Connah's Quay Low Carbon Power

Change Application Report

Planning Inspectorate Reference: EN010166

Document Reference: EN010166/10.1

FIGURE NUMBER
Figure 1

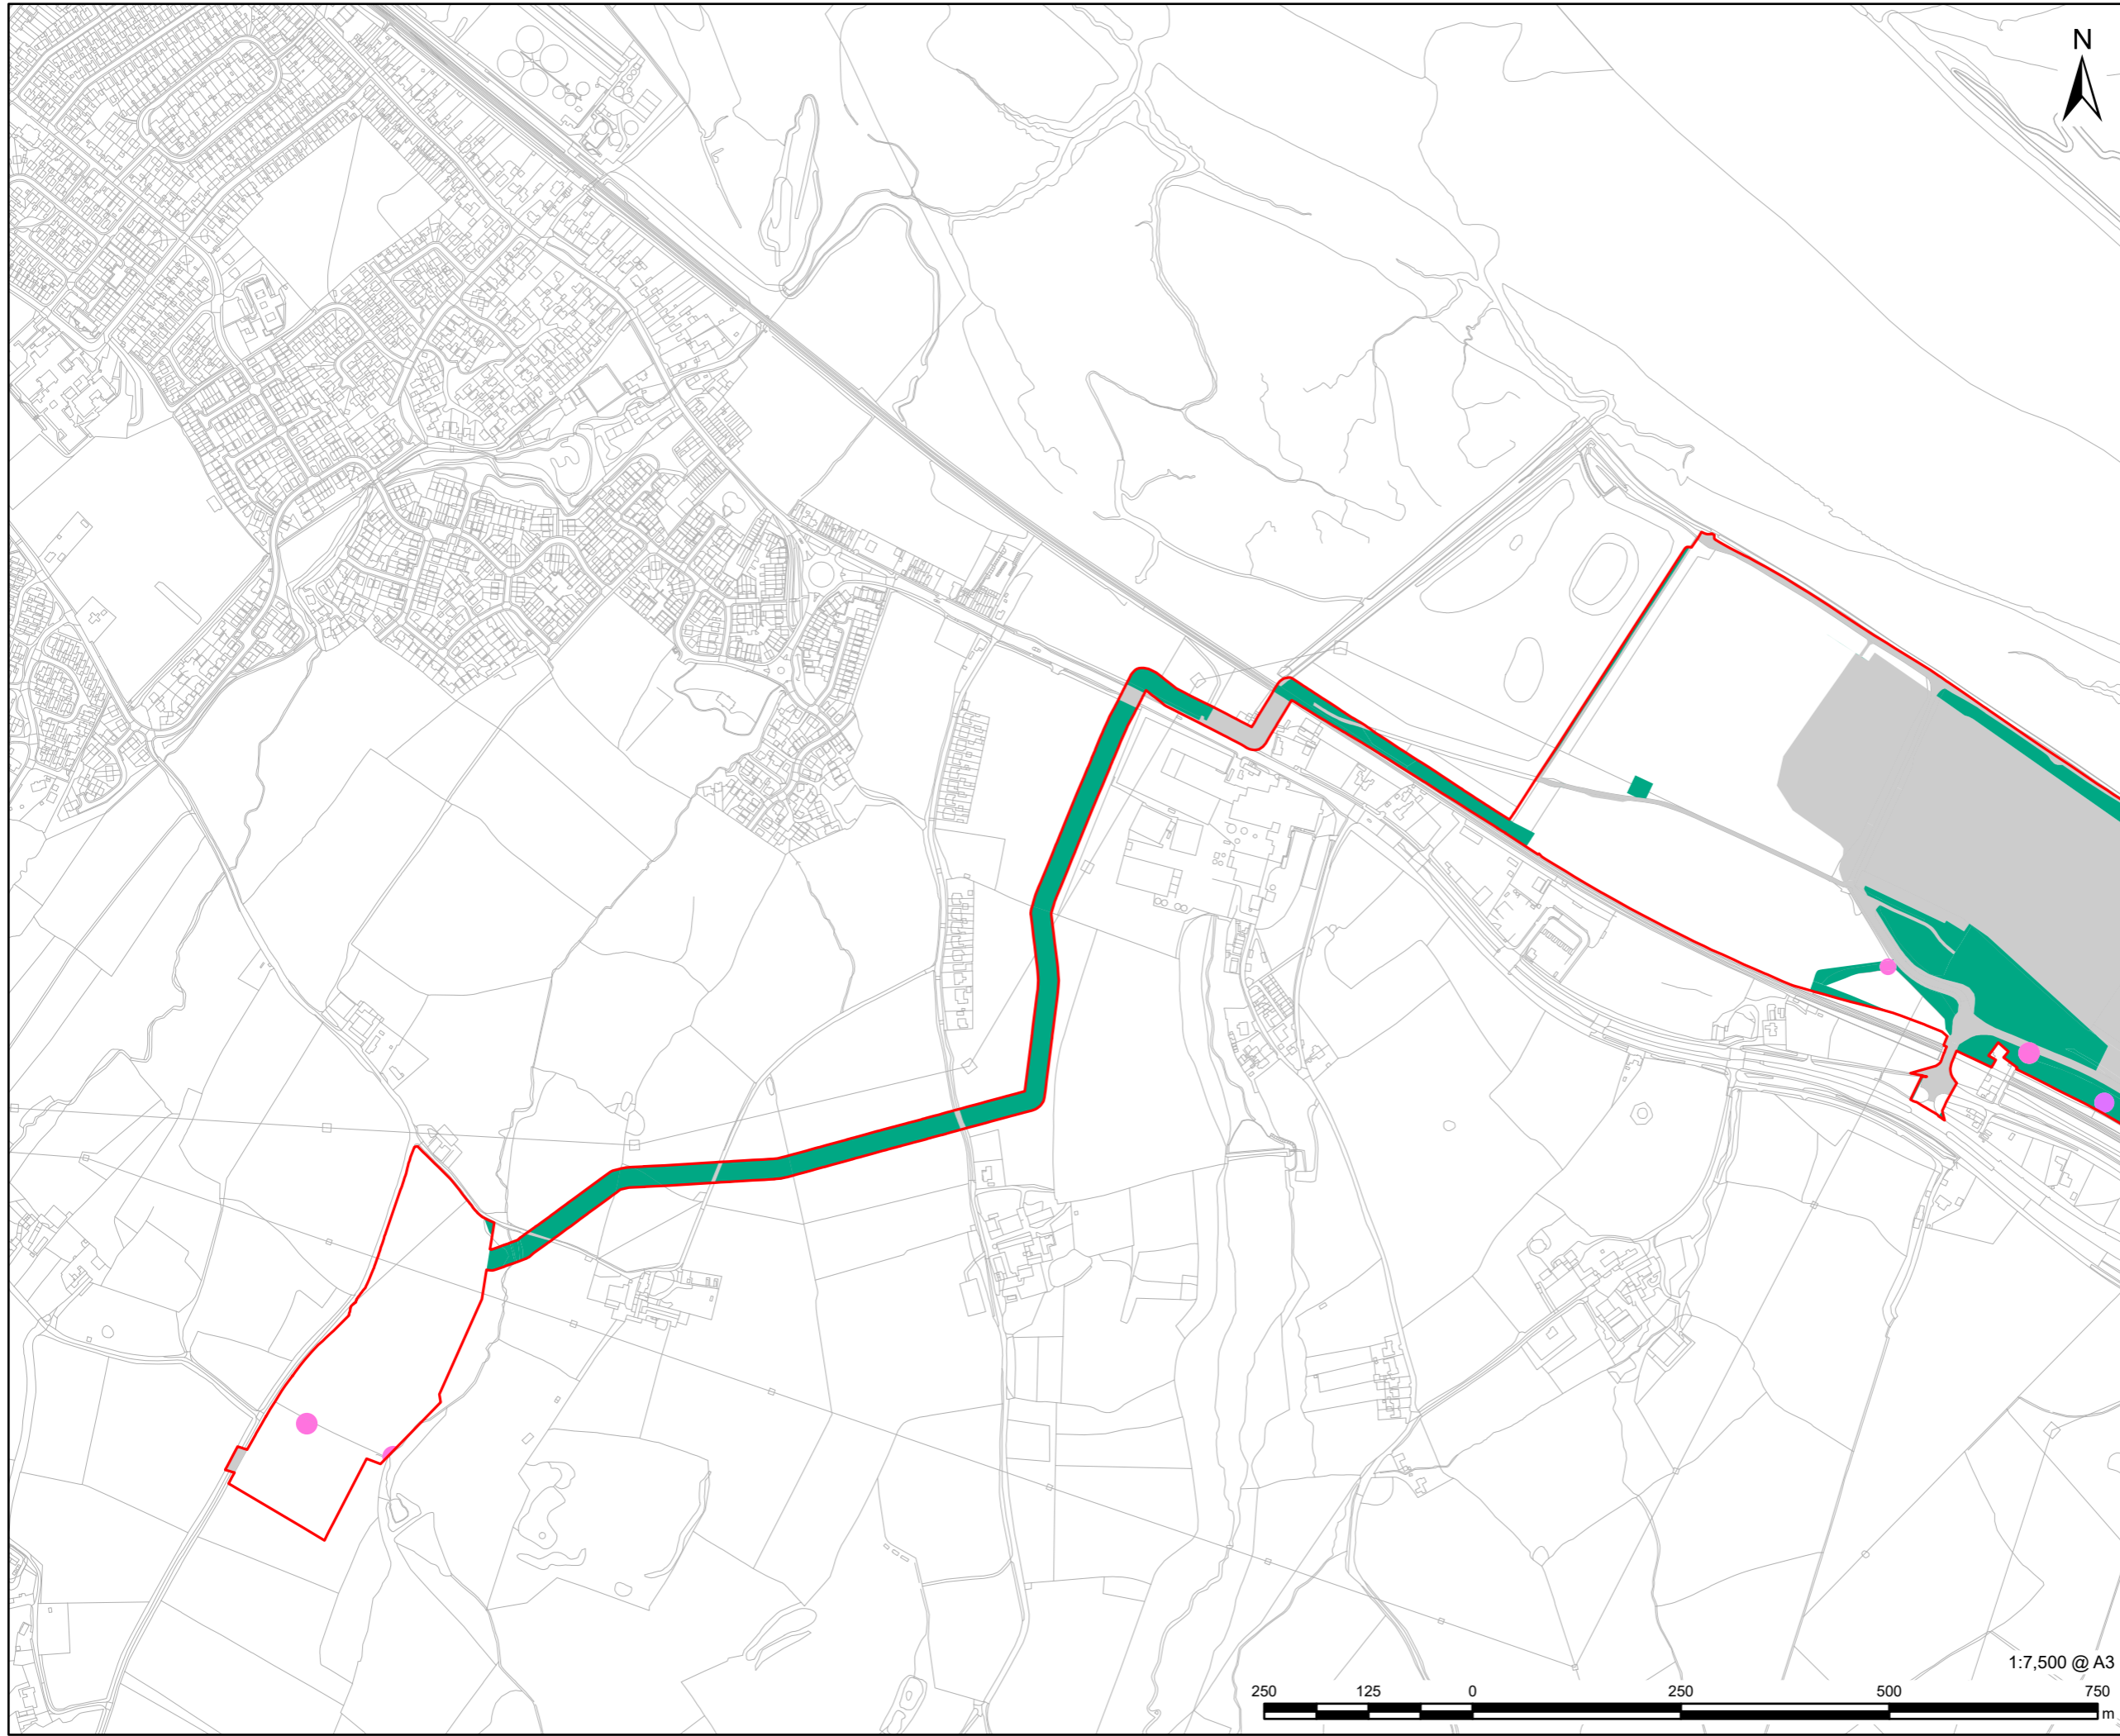
Proposed Development includes the construction of short lengths of new pipeline to facilitate connections into the Flint AGI to be constructed as part of the HyNet CO₂ Pipeline Project. All works to construct the Proposed CO₂ Connection pipeline within the overlapping area would be carried out by Liverpool Bay CCS Limited. Refer to **Figure 1: Land Acquisition Plot Comparison** in **Appendix A** for further details.

FIGURE TITLE
Areas Removed from Retained Habitat
Sheet 1 of 2

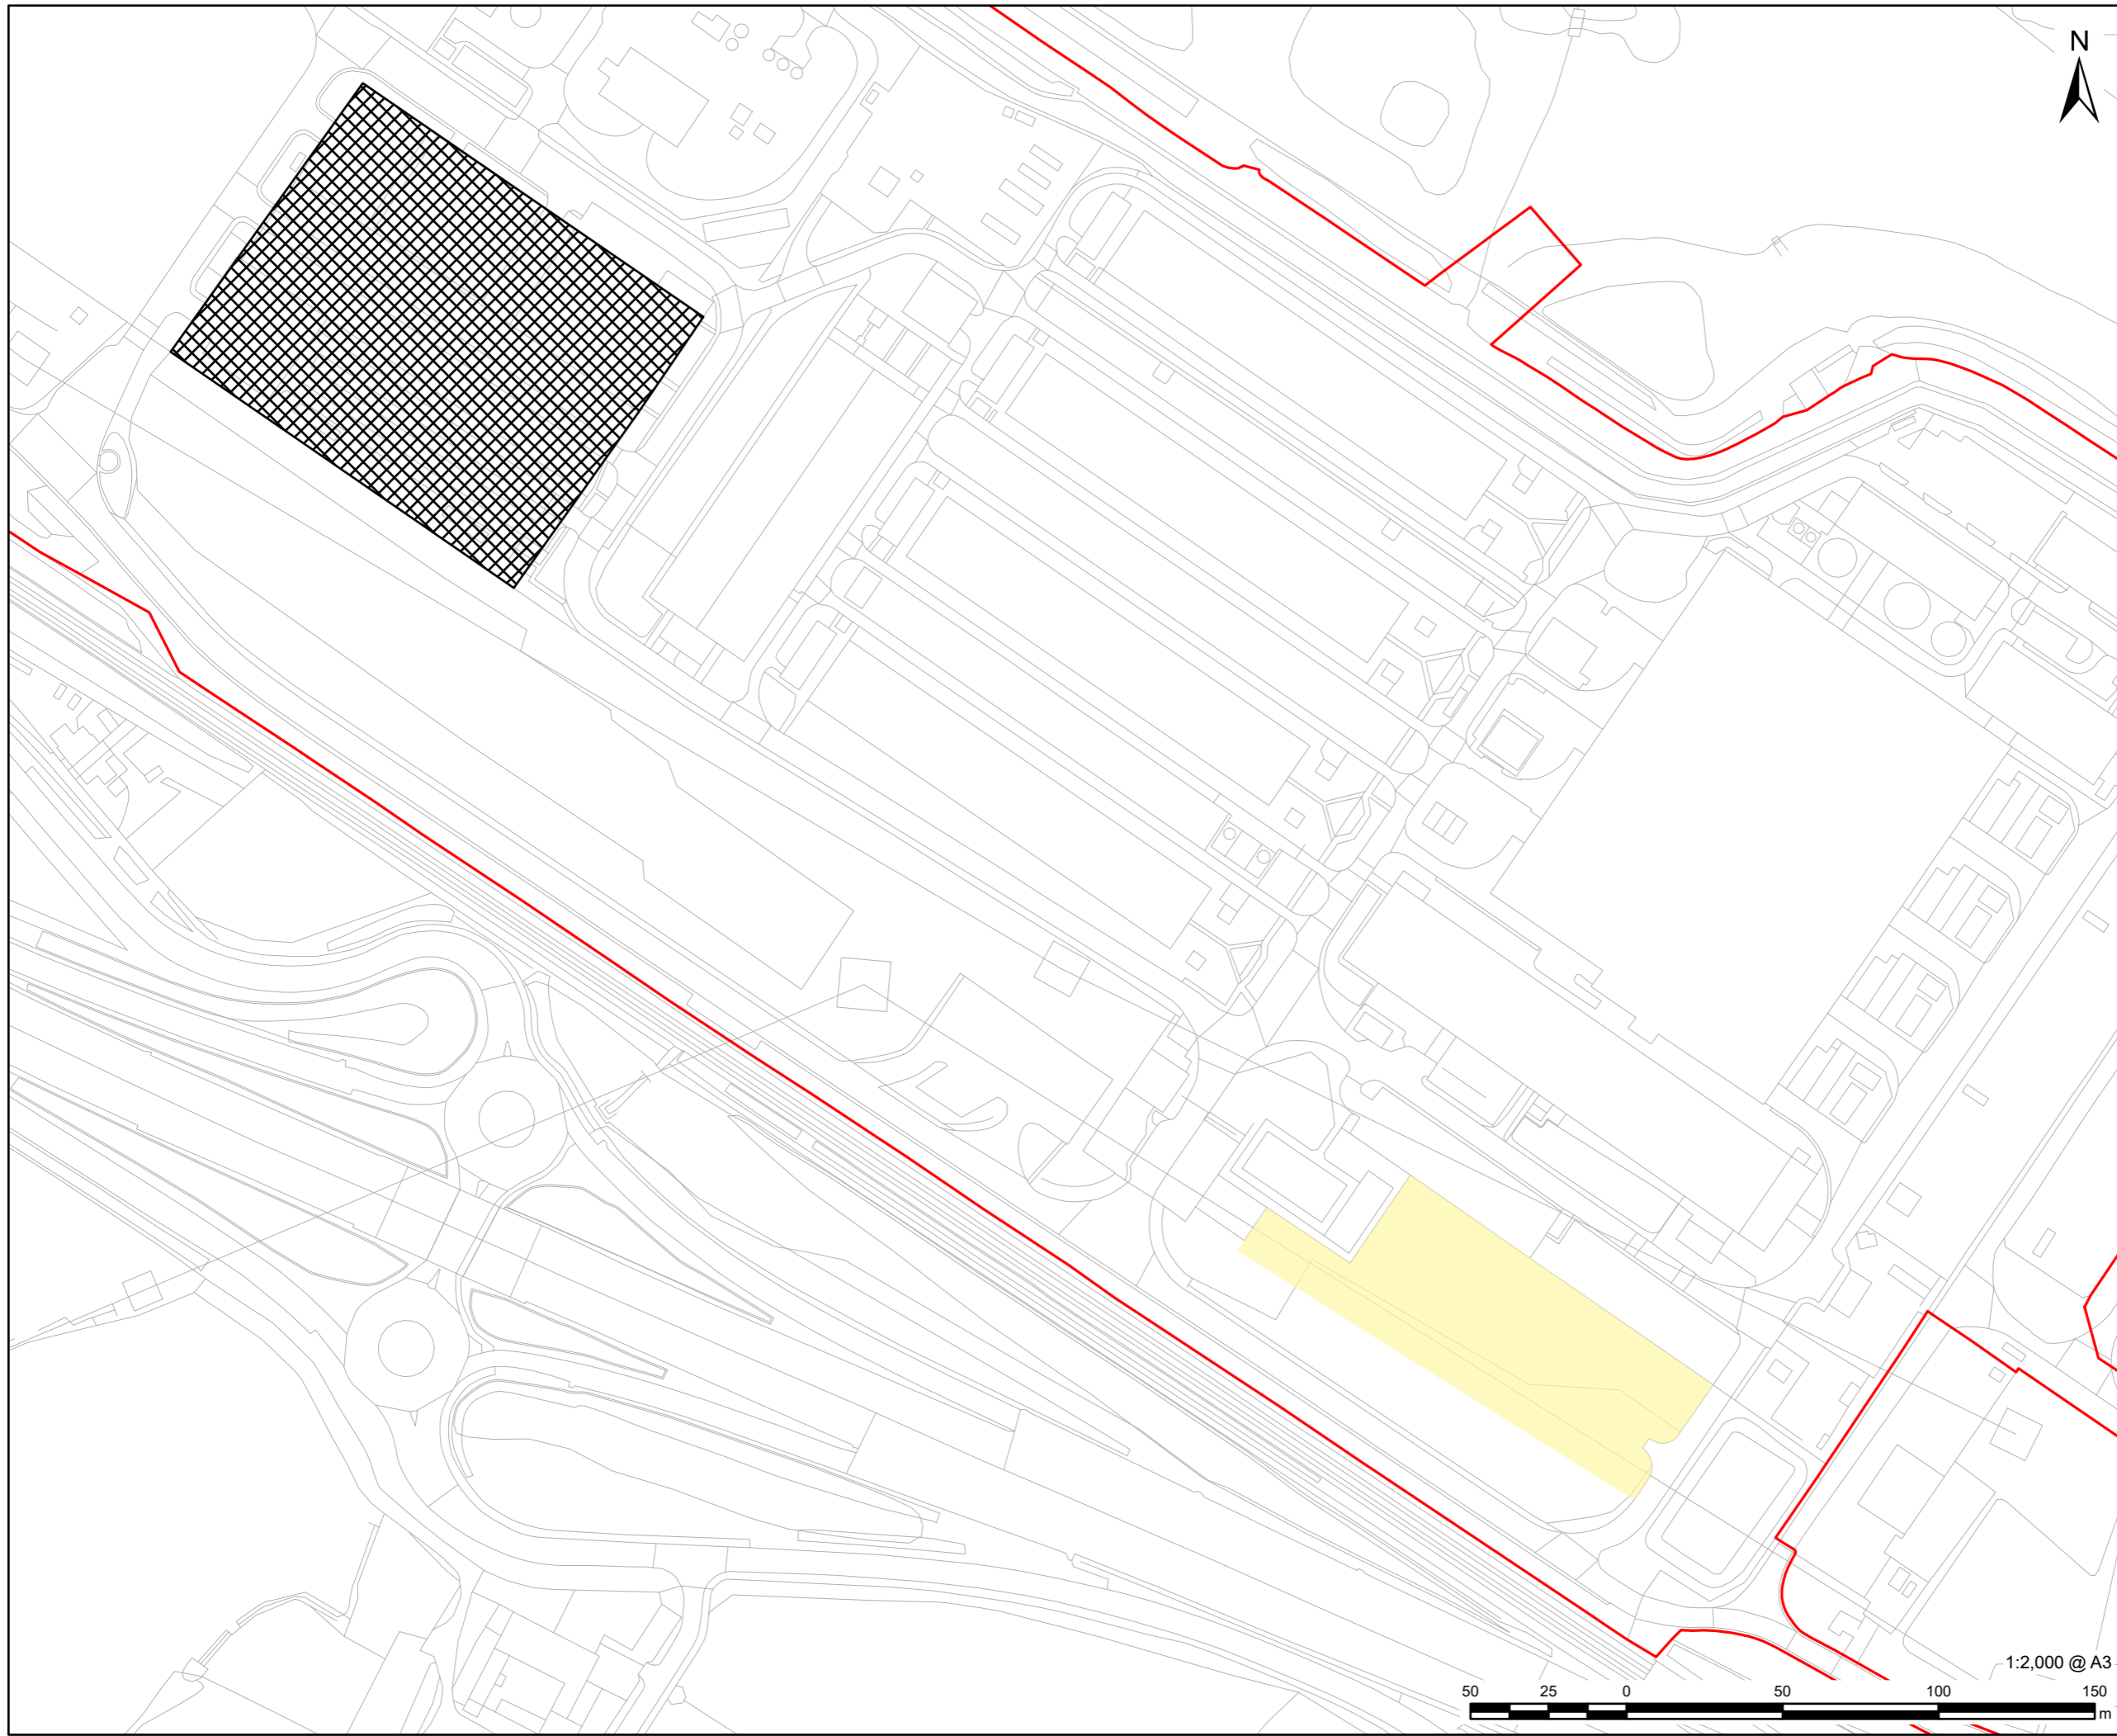
- 2.4.1 Change 3 involves minor changes to areas of retained habitats within the Main Development Area.
- 2.4.2 Seven areas within the operational fence line (including the Contractors' Facilities Relocation, Change 4) of the existing Connah's Quay Power Station were originally designated as retained habitat within the **Outline Landscape and Ecology Management Plan (LEMP) (EN010166/APP/6.9)** submitted at Deadline 3, **Green Infrastructure Statement (EN010166/APP/6.11)** submitted at Deadline 3, and accompanying plans. These areas consist of habitats of low ecological value (modified grassland, introduced scrub, and small patches of mixed scrub). At the time the UK Habitat Classification surveys were undertaken, detailed in the **Green Infrastructure Statement (EN010166/APP/6.11)** submitted at Deadline 3, the areas shown in **Figure 3** of the **Green Infrastructure Statement (EN010166/APP/6.11)** were assumed to be 'retained' habitat. This equated to no net loss and therefore required no net benefit for biodiversity (NBB) compensation.

- 2.4.3 During a detailed review of the Applicant's existing operational activities, it has become clear that these areas are required to accommodate routine operational activities associated with the existing Connah's Quay Power Station and are reserved by the operator for future use as laydown areas in connection with that power station. Committing to retaining this habitat within the operational footprint of the existing Connah's Quay Power Station would restrict the ability to manage plant and store equipment, as well as introduce potential access restrictions associated with day-to-day operation and maintenance.

- 2.4.5 **Figure 2: Areas Removed from Retained Habitat** in **Appendix A** identifies the specific areas within the Order limits that will change classification from 'retained' to 'permanent loss'. The total habitat area changing from retained to permanent loss is approximately 1.25 ha, including the contractors' facilities. As these areas support habitat of low ecological value and have limited habitat connectivity to the wider site, it is proposed that additional NBB will be delivered within the off-site mitigation area, located at Gronant Fields, Prestatyn to complement Curlew mitigation (see the **Offsite Net Benefit for Biodiversity and Green Infrastructure Strategy (EN010166/APP/6.14)** submitted at Deadline 3, for further detail). Mitigation measures include the provision of additional species-rich grassland, building upon that already committed as part of the Proposed Development.
